M602 PCB DATABASE HISTORY

MODEL(S):- YCV80

Yorkville	Product YCV80		
	Guitar Amp	PCB# M602	Sheet 1 of 2
	Date: Tue Sep 05, 2006		Rev:10.00
	Filename: M602-10V00sch.SCH2002

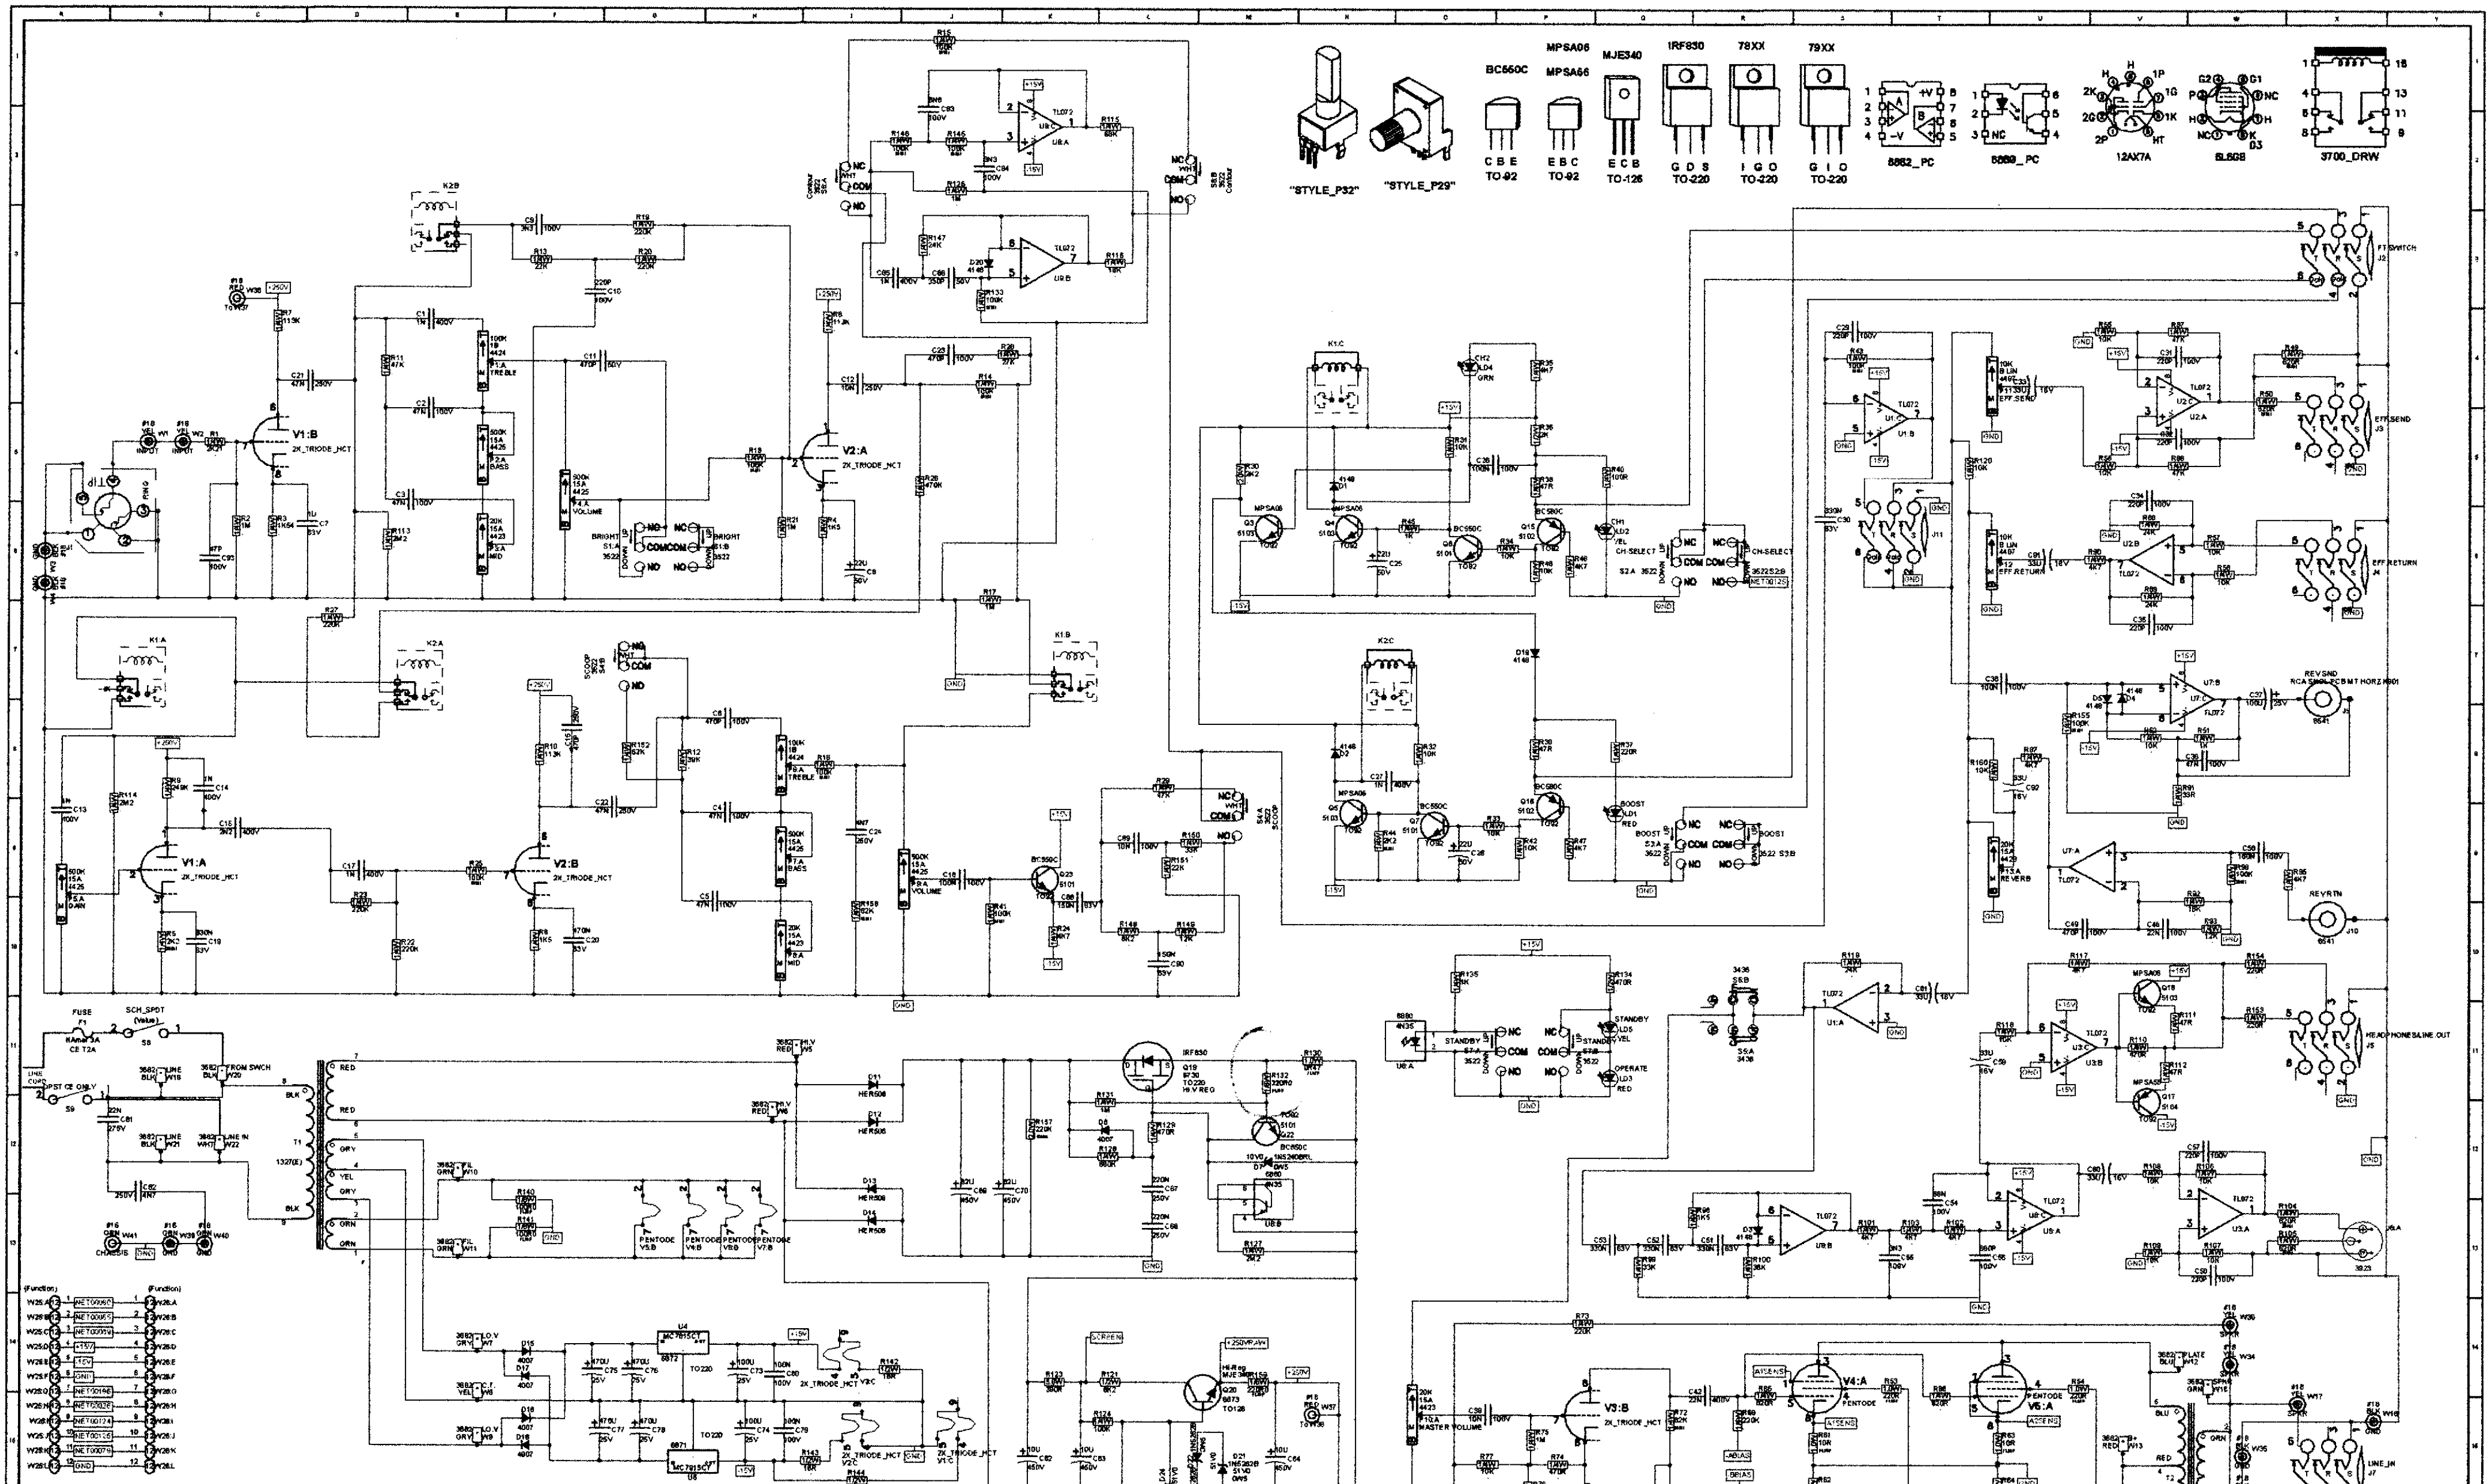
#	DATE	VER#	DESCRIPTION OF CHANGE
1	2001 06 08	1.00p0	First Prototype
2	2001 06 06	1.00p1	Remove cutouts for BE tube sockets, move ribbons cables
3	.	.	to line up, change shearing to routing
4	2001 07 05	1.00p2	Moved Send and Return pots out 0.075"
5	.	.	Added Skm outline to BE tube sockets
6	2001 08 13	1.00	Value changes to tweak sound
7	2001 09 20	2.00	Add C166 10N across R122
8	.	.	Move C93 47P to be across R2
9	.	.	Add R160 10K from wiper to top of P13
10	.	.	Add R159 in series with Q20 output.
11	2001 10 10	2.10	pc#6544 D6 30V ->33V, C19 150N ->330N, C20 330N->470N,
12	.	.	C16 1N->470P, C17 470P->1N, R23,R23 470K->220K
13	.	.	C39, C40 100N->10N

#	DATE	VER#	DESCRIPTION OF CHANGE
1	NOV 18 2002	7.00	MOVE D11 D12 D13 D14 TO ELIMINATE
2			SHORTS
3	NOV-01-2004	8.00	PC#6728:TUBE LABELS UPDATED TO V1 TO V7 (GT)
4	JAN/04/2005	8.10	PC#6789 D11,D12,D13,D14 1N5408 TO HER508 (HG)
5	JAN-06-2005	.	ADDED Z437 HEATSINK (GT)
6	APR-15-2005	.	PC#6793, PC#6795: FIX BREAKAWAY AND RTE NEAR S6
7	MAY-17-2005	9.00	GT:FORCE UPDATE PADS REQUIRED TRACE CHANGES
8	.	.	R94 #4849 -> #4796 180K, REPLACED LEAD_SIZE PARTS
9	MAY/12/06	10.00	PC#7125:HG: RCA JACKS #3914 TO #6541
10	MAY/23/06	.	PC#7091:HG: #3622 SWITCH HOLES 0.031" TO 0.040"
11	D	V	N
12	D	V	N
13	D	V	N

#	DATE	VER#	DESCRIPTION OF CHANGE
1	2001 10 17	2.20	PC#6466 C16 1N TO 2N2, C11 220p TO
2	.	.	470P, R148 10K TO 8K2
3	NOV 30 2001	2.30	PC#6475 REPLACE R126,R122,C87,Q21 WITH D6,D22,D23,D24
4			D25,D26 51V ZENER IN SERIES
5			C86 220N/250V TO 10u/450V
6	JAN/17/02	3.00	PC#6494 UPDATE SOLDERMASK FOR RCA JACKS AND TABS
7	FEB/26/02	4.00	PC#6512 D11,12,13,14 MR854 TO 1N5408
8	D	V	NEW PADS FOR TABS, RCA JACKS
9	Apr 10,2002	5.00	new pads and holes for 3921 jack
10	APR 29 02	.	C15 MOVED ADD JUMPER X64
11	JUN 26 2002	6.10	PC#6541 R124 100K TO 47K
12	JUL 06 2002	6.00	PC#6544 MOVE TRACES RE SLD BRDGING
13	SEP 03, 2002	6.10	PC#6563 R124 47K TO 100K D25 TO A JMP
